Product: DVD Receiver

Hardware Technical Bulletin: L70-H2004-05

Date: June 21, 2004

Subject: Fan Kit Installation

Figure 1

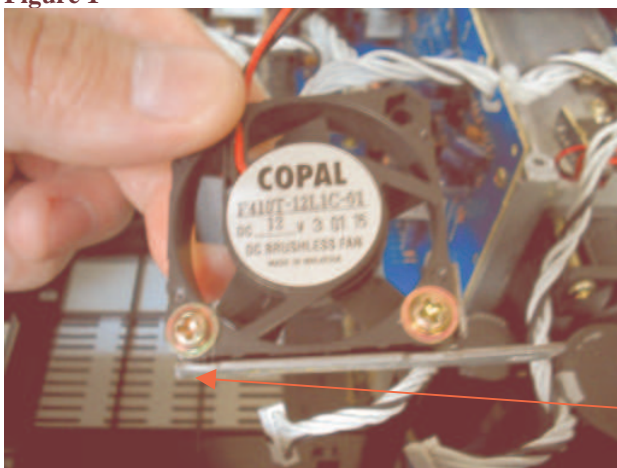
1. As shown cut the supplied bracket in order to install it with the new fan.
2. Secure fan to the bracket and add some glue to the bottom of the bracket when securing to the chassis. See figure 1 and 2.

Cut bracket here

Figure 2

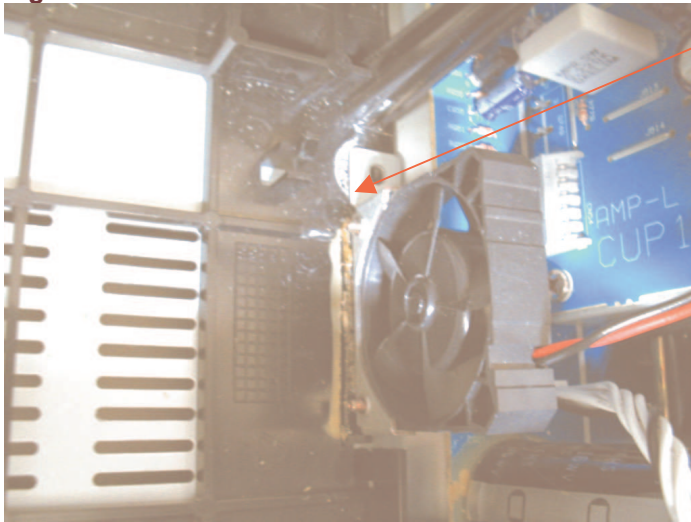
Glue bottom of bracket to chassis

Figure 3

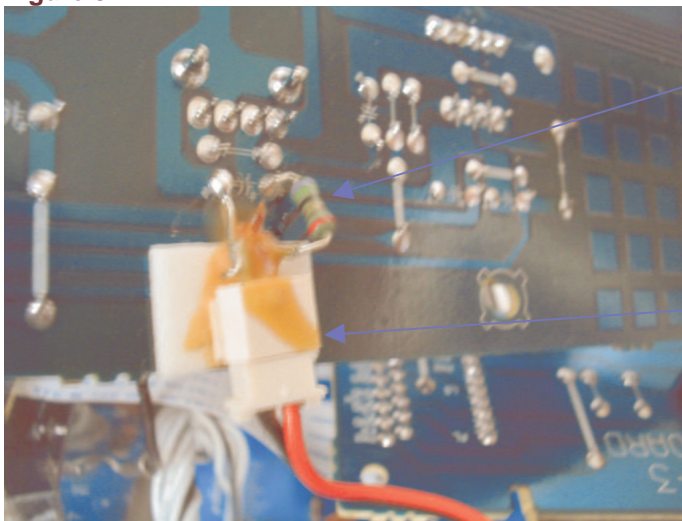
3. Replace R922 (100 ohms) and solder the 82 ohm resistor supplied, to one leg of the male plug and solder the other to capacitor C 905 + side. This is on the bottom of the main cpu pc board which mounts to the top of the dvd player mechanism.

R922 on bottom of pc board 100 ohm changes to 82 ohm.

Figure 4

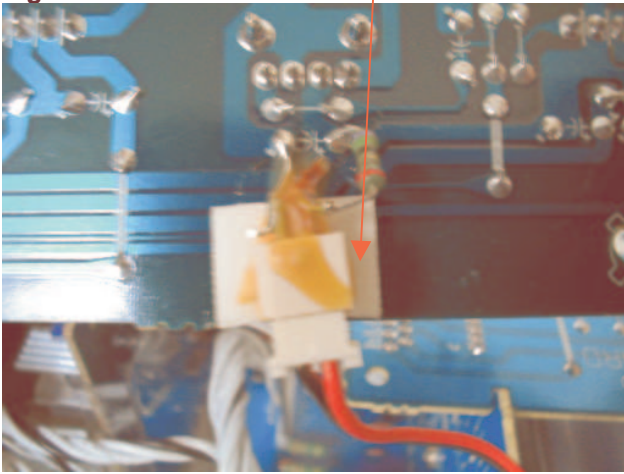
4. Glue connector to PCB as shown in figure4.

Figure 5

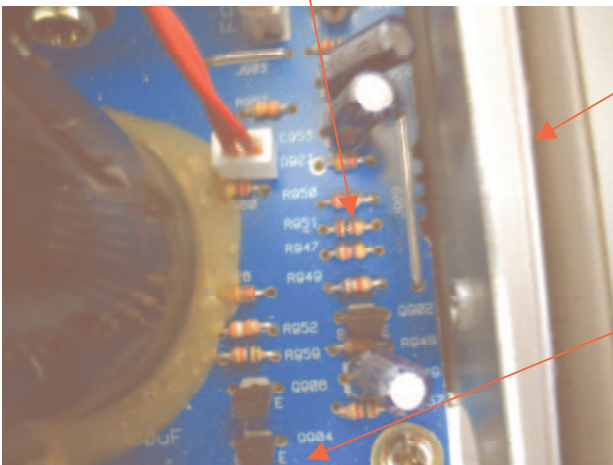
5. Replace 100 Ohm R951 on the main PCB, located under the power amp heatsink and assembly, with the 91 Ohm supplied.
